**SUPPLEMENTAL BID BULLETIN**  
**ADDENDUM NO. 2026-17-01 R**

**Subject: Supply, Delivery, Installation, Testing, Training and Commissioning of S-Band Dual Polarization, Magnetron-Type Doppler Weather Radar at Brgy. Buenavista, Bato Catanduanes – Re bid**  
*(Reference: PR 2025-10-0666 EPA- | IB 2026-17R)*

DRAWING TITLE  
**Equipment Layout Plan-2**

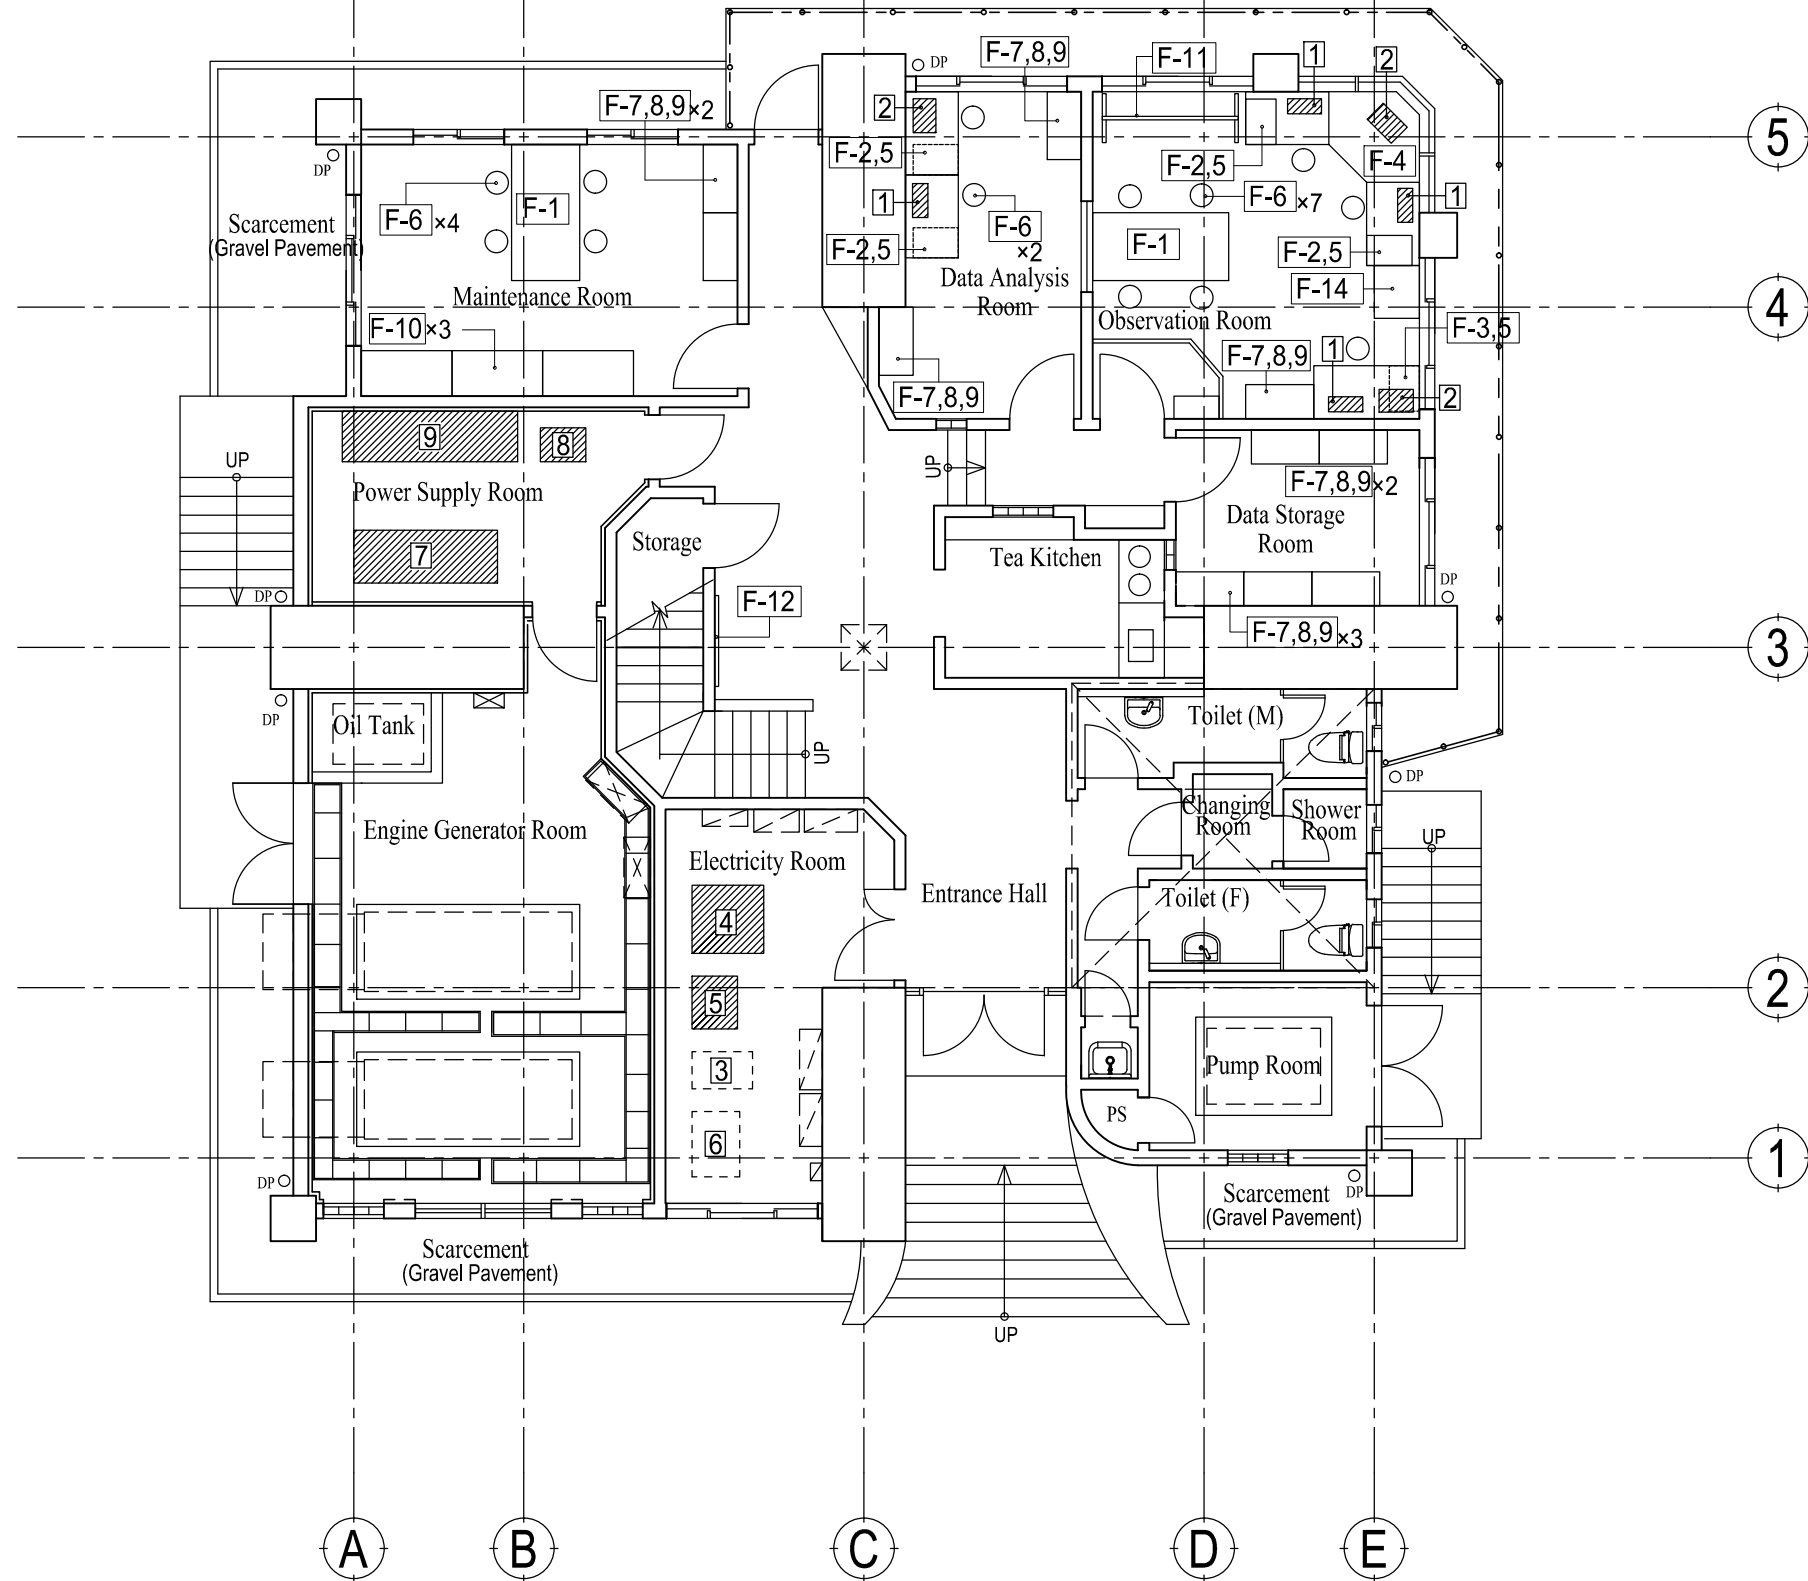
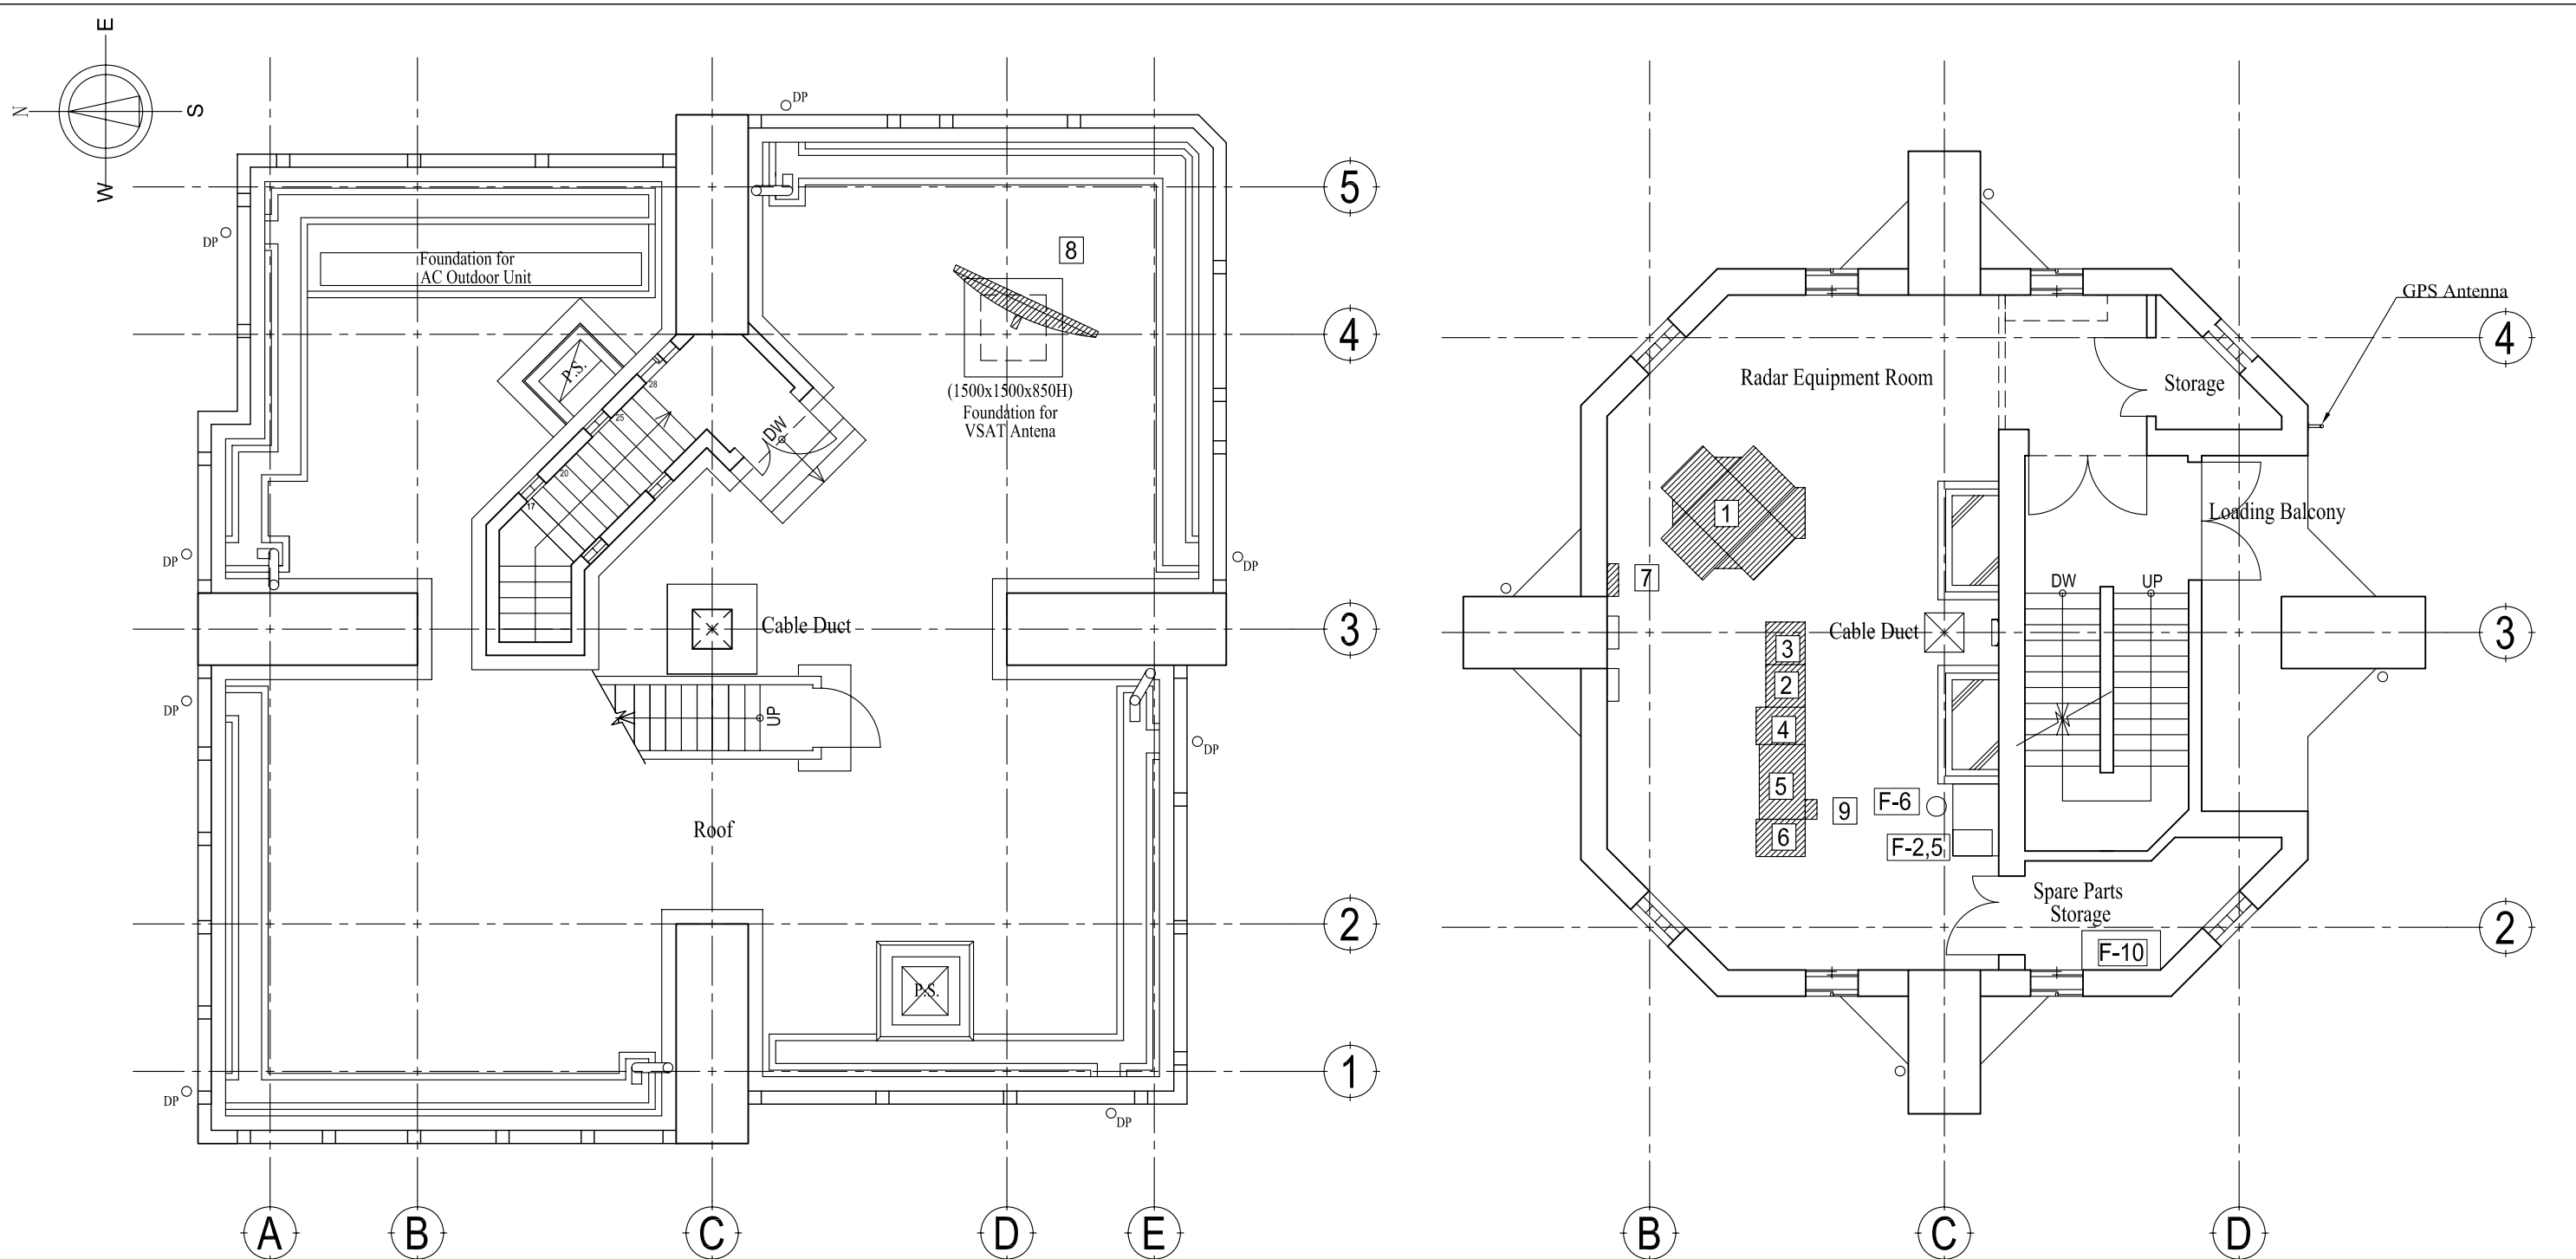
<p><b>6. 9.16.2.2 Generator Sets</b></p> <p>Request of the floor plan layout with dimension where the Generator Sets will be installed, and for the replacements of exhaust/cooling system.  Will it be Indoor or Outdoor?</p>	<p>The prospective bidder shall accurately measure the generator pads during the required site assessment, particularly as the existing generator sets will be dismantled, to ensure proper fit and compatibility of the new generator installation.</p> <p><i>(refer to Annex 10 - floor plan)</i></p>
